# PUYALLUP AOB

NE 1/4 OF THE SE 1/4 SECTION 28, TOWNSHIP 20N, RANGE 4 E  
Puyallup, Washington

**COVER SHEET**

WATER DETAILS  
DRAWING NO. 12 OF 30  
WA-02

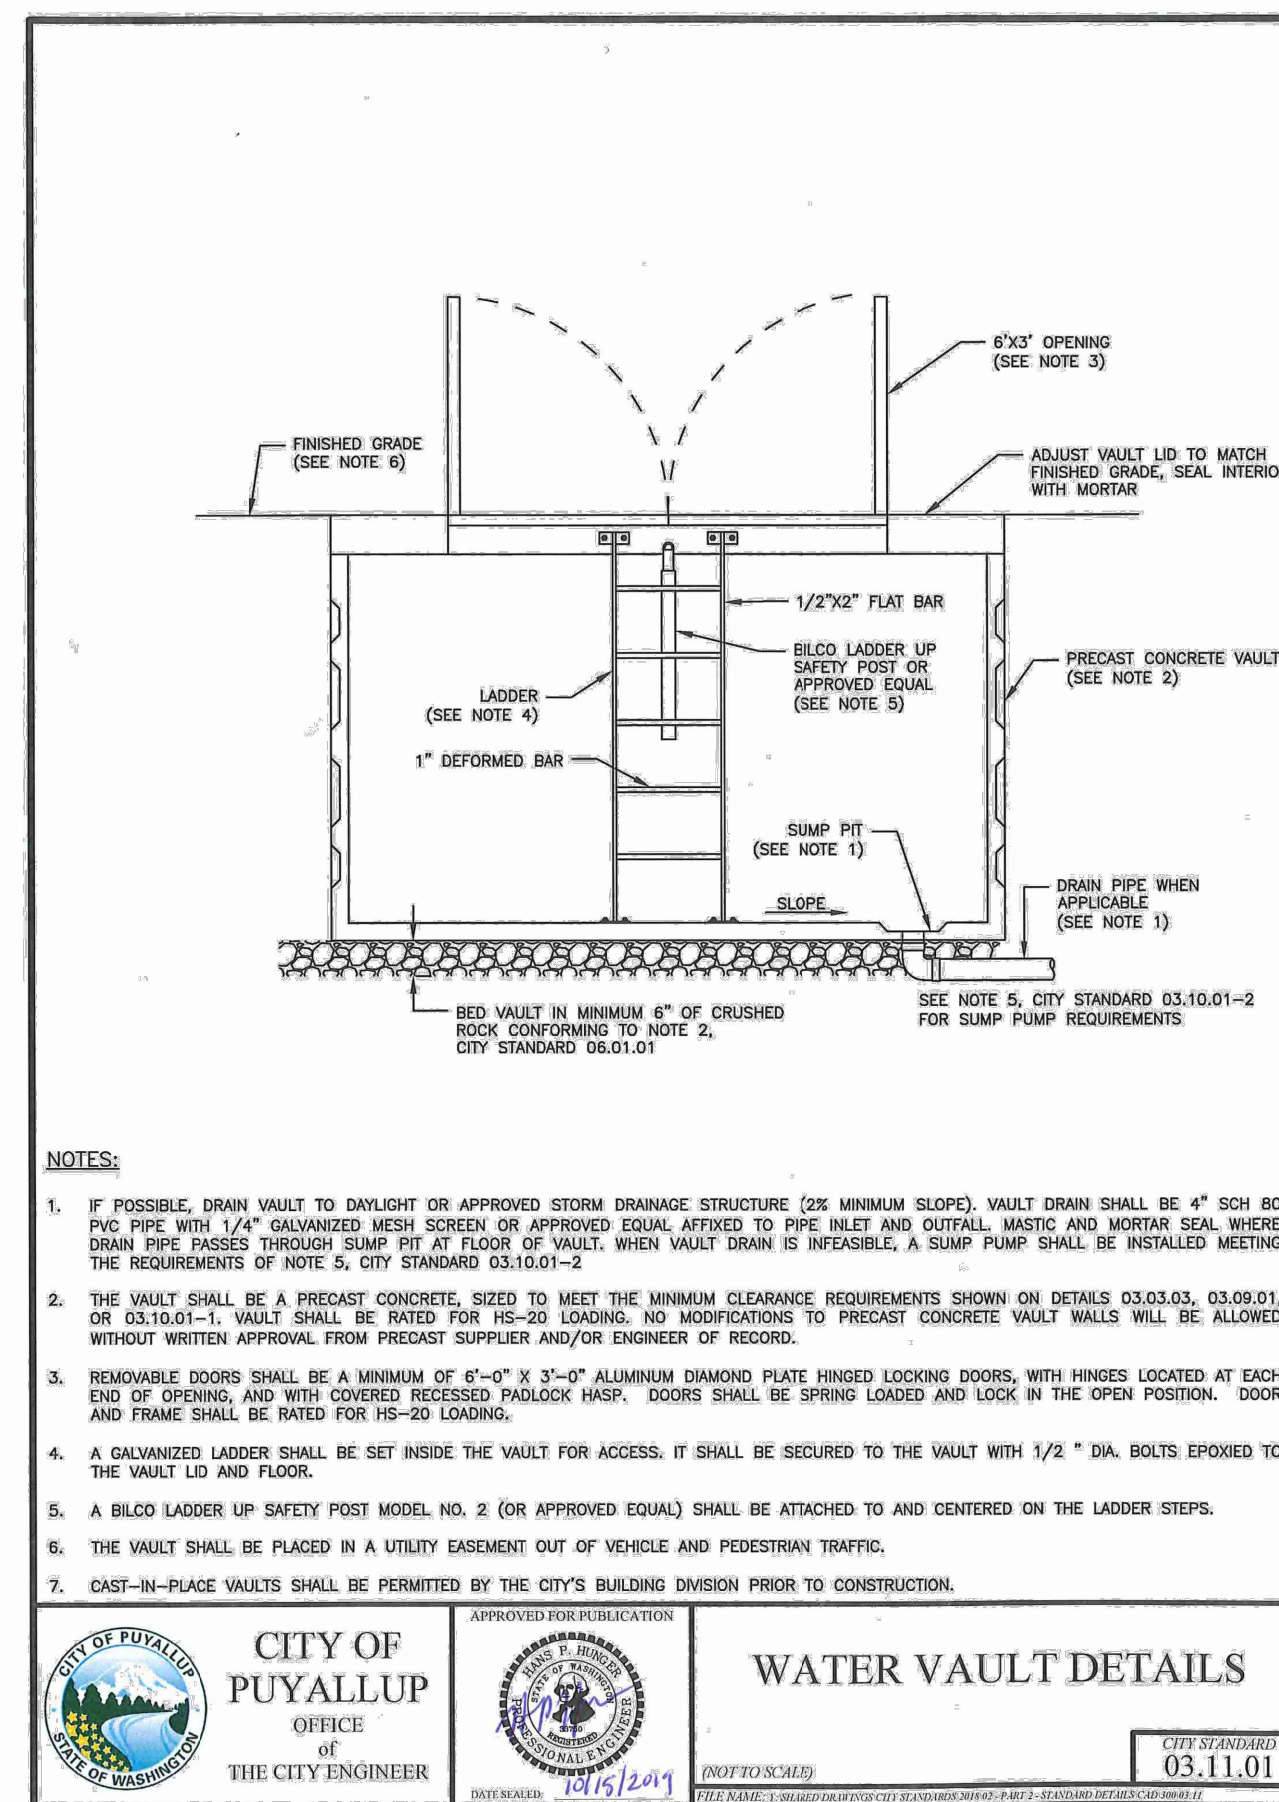
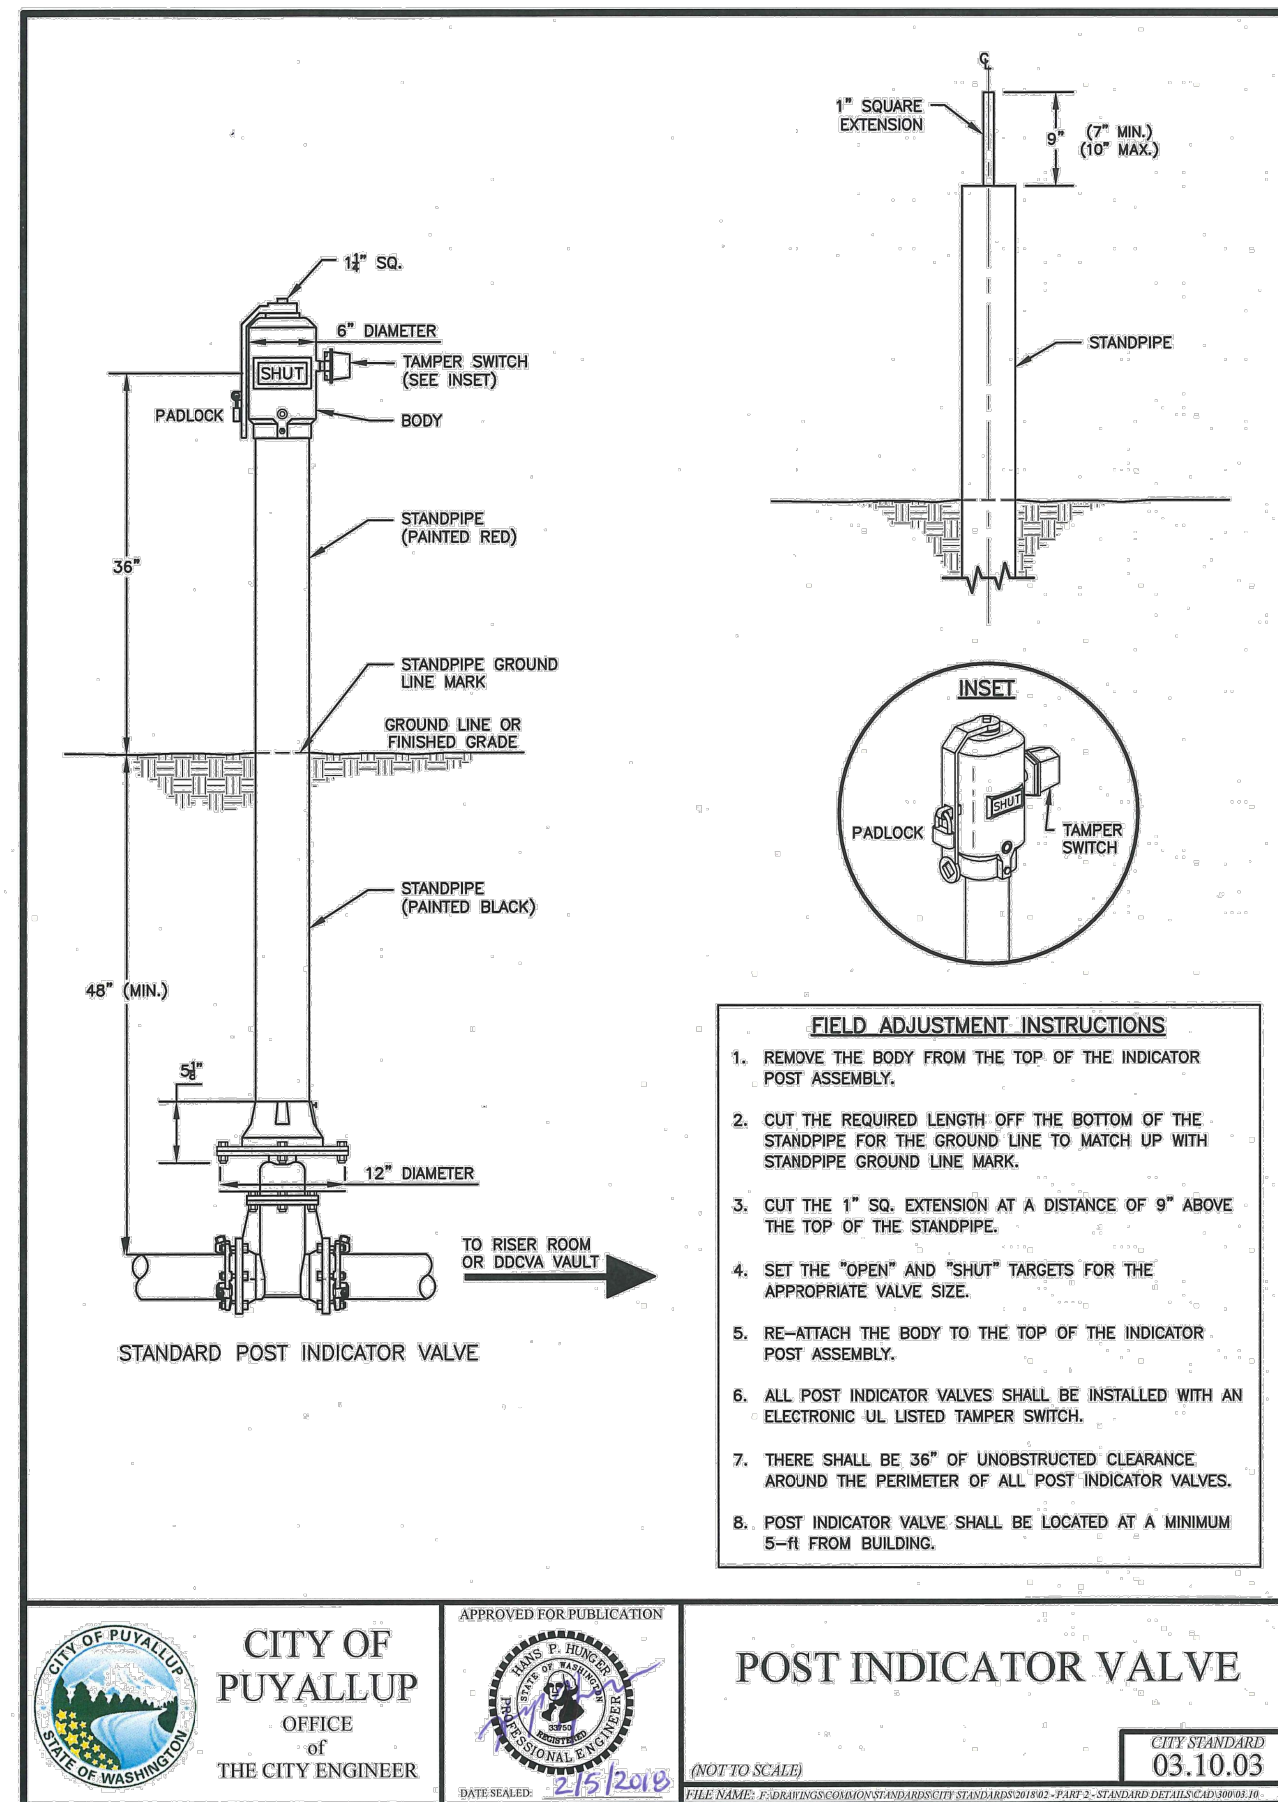
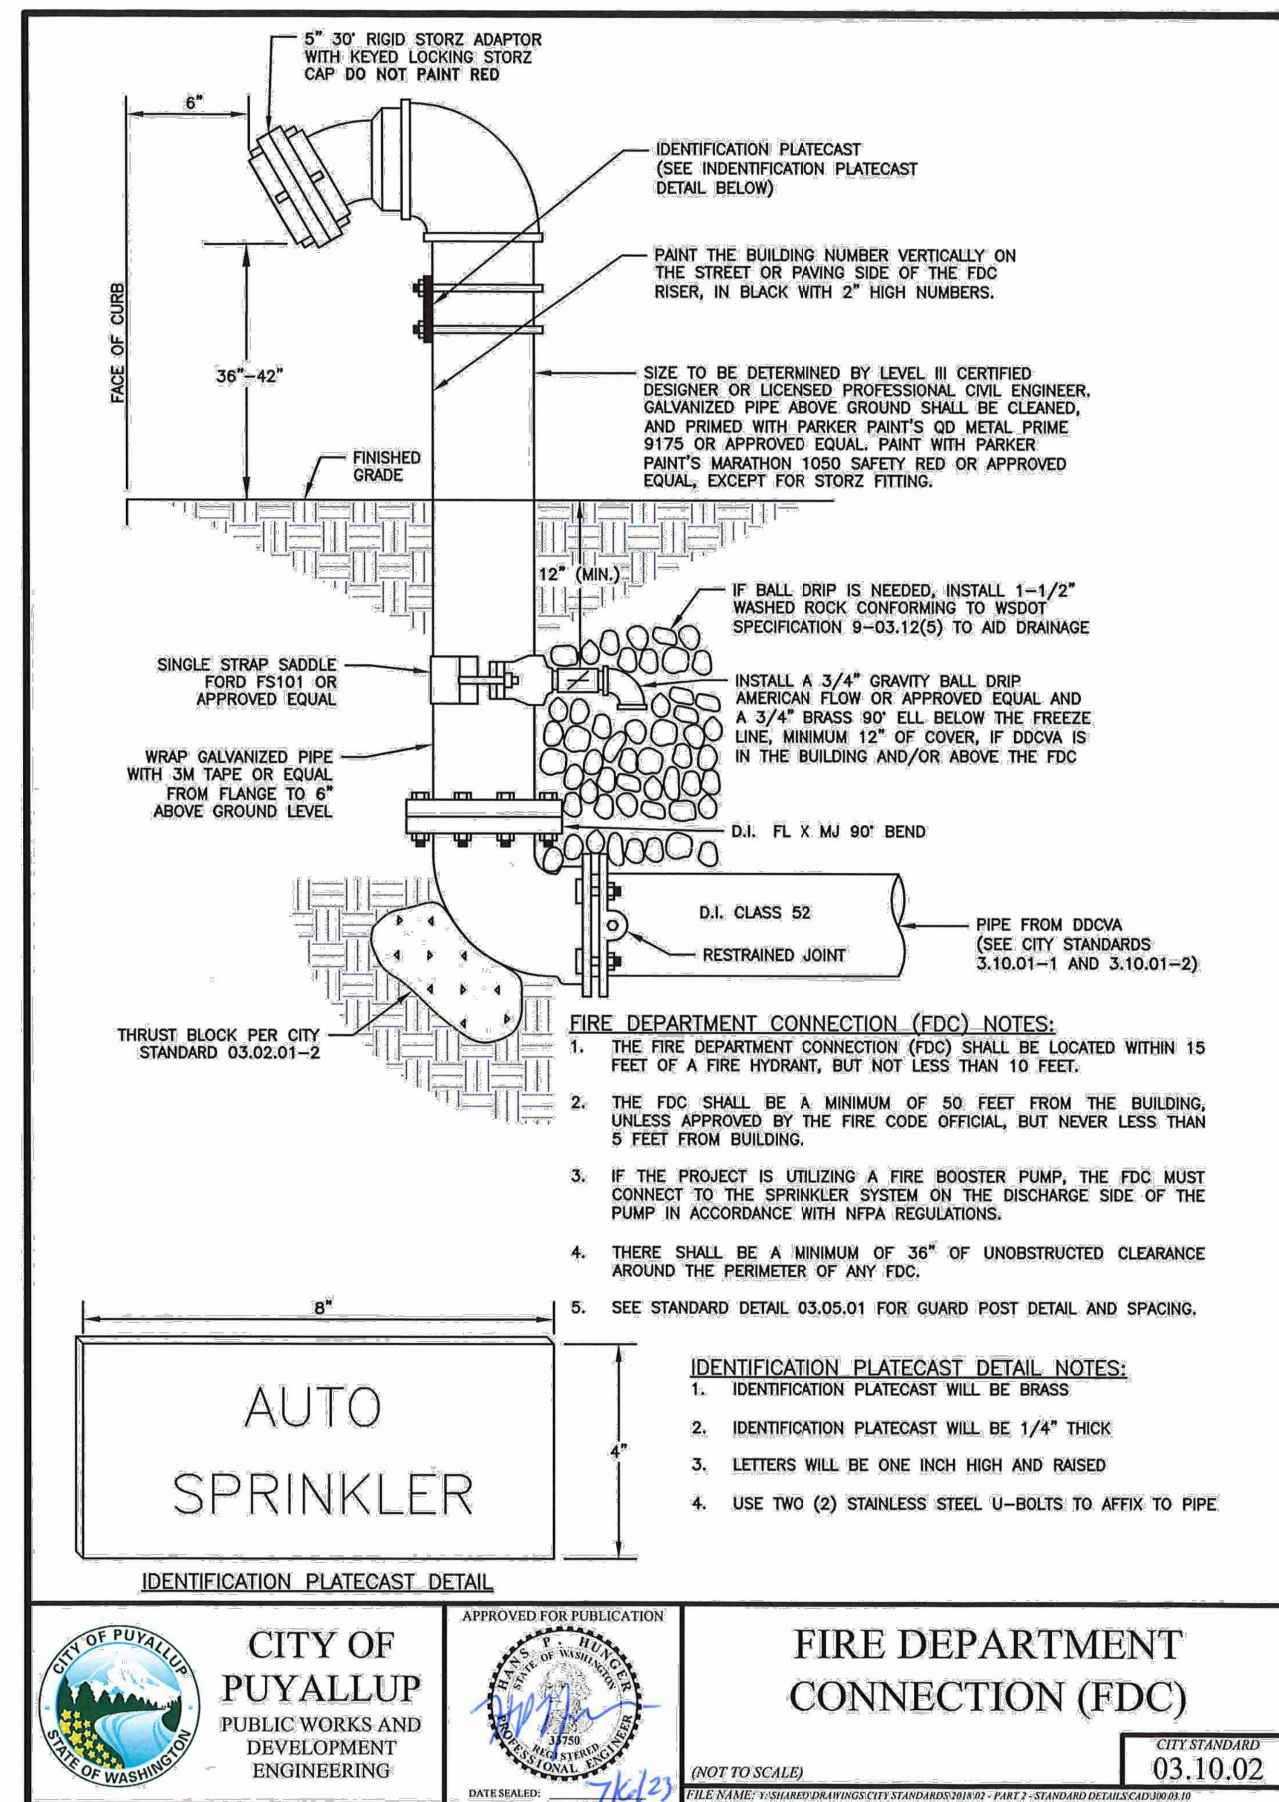
Add City Standard details 03.03.01 and 03.04.01 to this plan set.

DRAWING NO.  
 16 OF 30  
**IL-01**

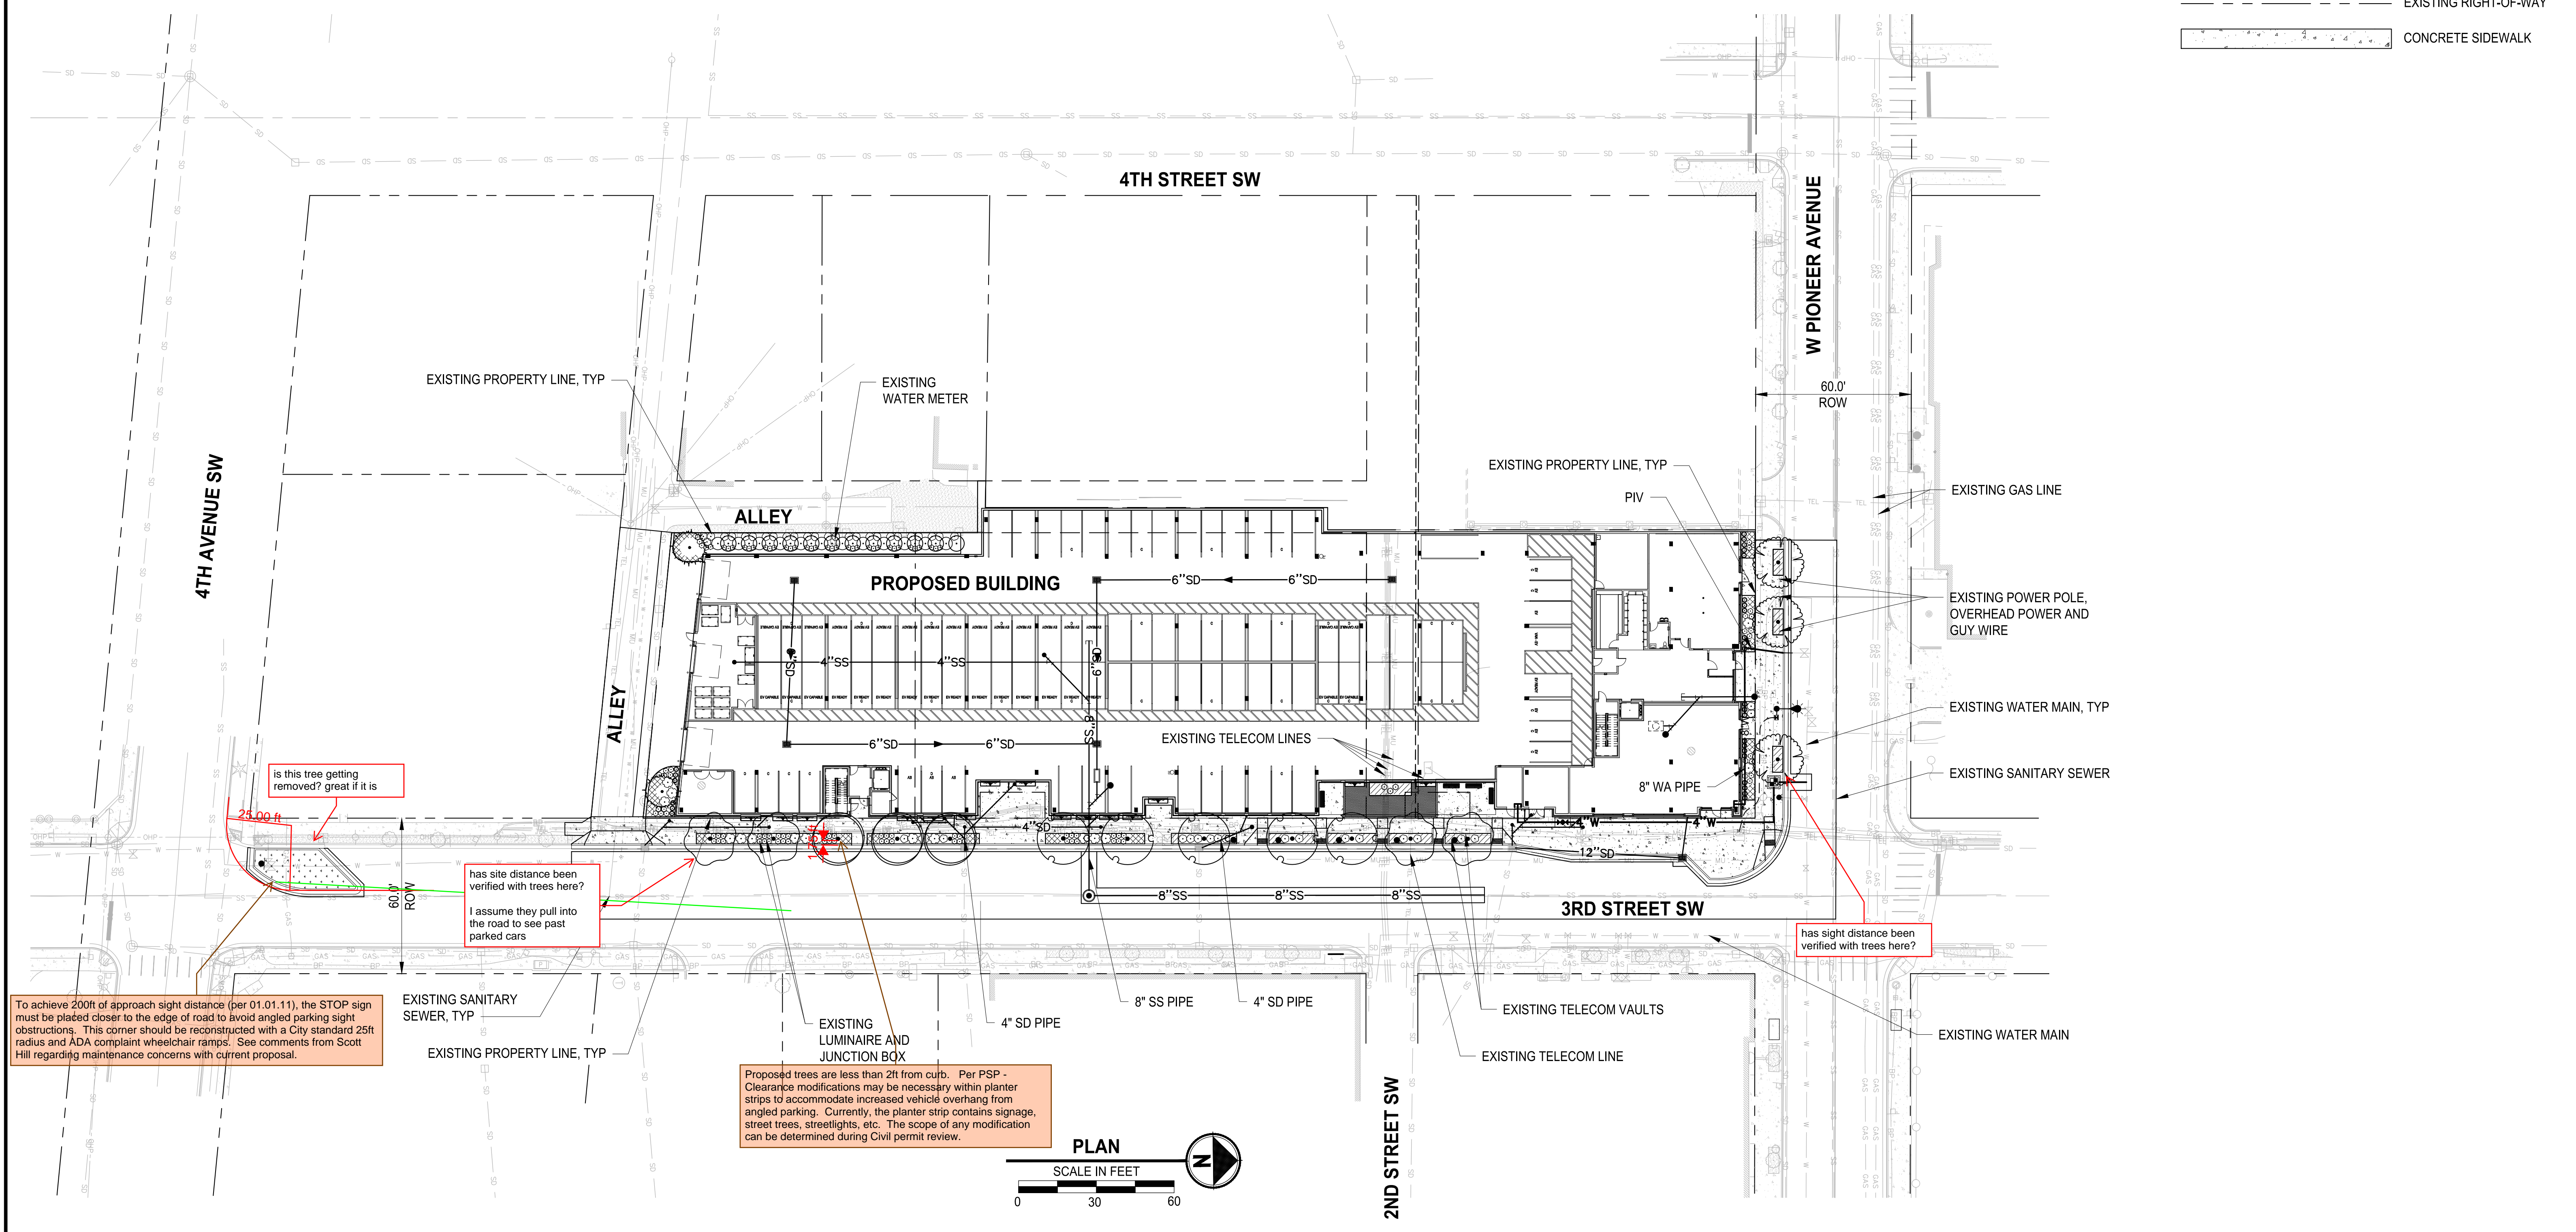
Show all City streetlights (labeled with construction note 4) within illumination design.  
 Streetlight design shall provide the following:  
 - Wiring Schedule  
 - Location of conduit runs  
 - Conduit size and type for each raceway  
 - Conductors details  
 - Pole schedule  
 - STA & offset for each luminaire  
 - Show location of junction boxes

has capacity for this been verified?, if not run conduit

add spare conduit for future use while sidewalk is being replaced

Per site visit, this light pole is 1.2ft from face of curb. Per PSP - Clearance modifications may be necessary within planter strips to accommodate increased vehicle overhang from angled parking. Currently, the planter strip contains signage, street trees, streetlights, etc. The scope of any modification can be determined during Civil permit review.

WIRE/CONDUIT SCHEDULE NOTES: add spare conduit ID
